DAVIS-BESSE NUCLEAR POWER STATION, UNIT NO. 1

AMENDMENT TO FACILITY OPERATING LICENSE

Amendment No. 207  
License No. NPF-3

Attachment: Changes to the Technical  
Specifications

Figure 3.1-1 Boric Acid Addition System  
 Minimum Required Volume as  
 a Function of Boric Acid  
 Concentration Required in  
 Modes 1-4

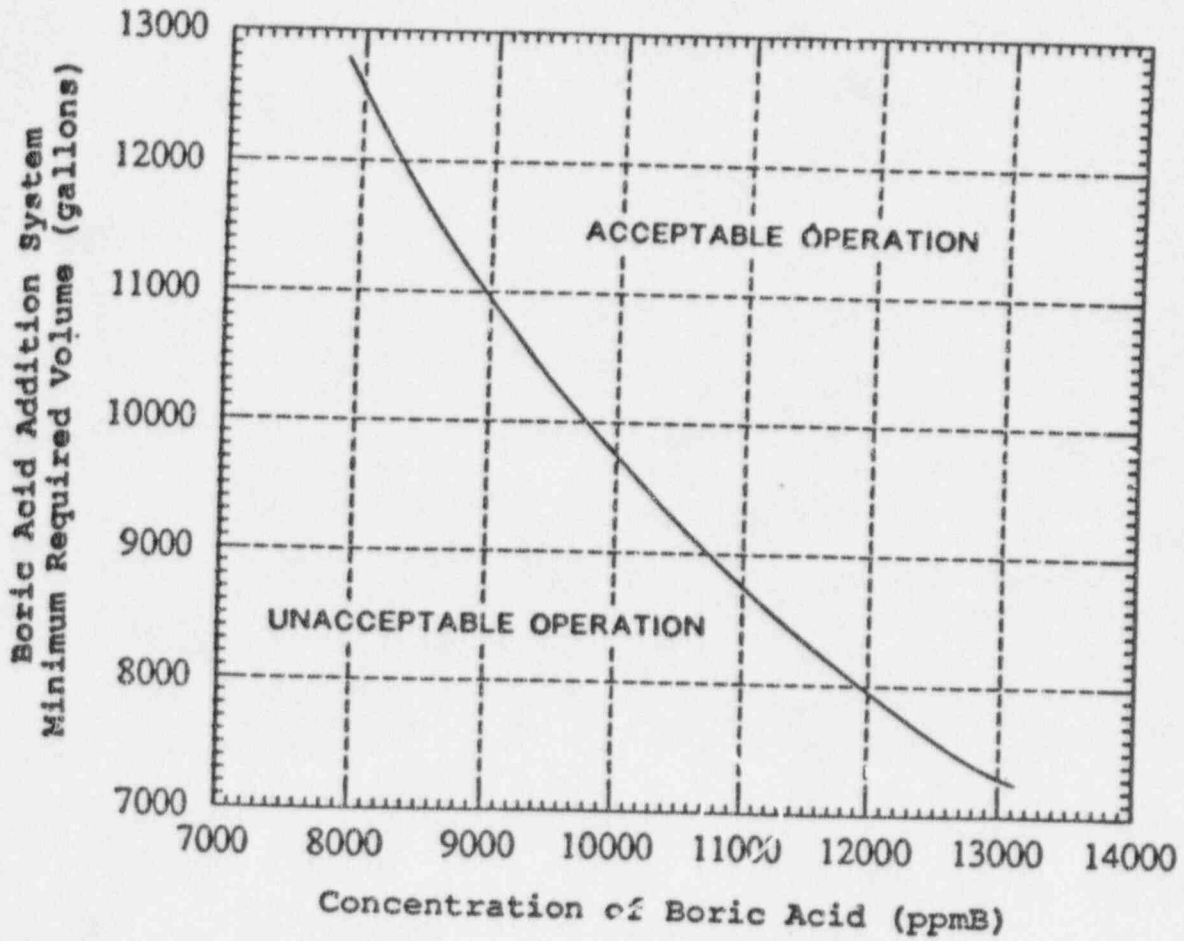
- a. The boric acid addition system (BAAS) with:
  1. A minimum available borated water volume in accordance with Figure 3.1-1,
  2.  $\geq 7875$  and  $\leq 13,125$  ppm of boron, and
  3. A minimum solution temperature of  $105^{\circ}\text{F}$ .
- b. The borated water storage tank (BWST) with:
  1. An available borated water volume of between 482,778 and 550,000 gallons,
  2.  $\geq 2600$  and  $\leq 2800$  ppm of boron, and
  3. A minimum solution temperature of  $35^{\circ}\text{F}$ .
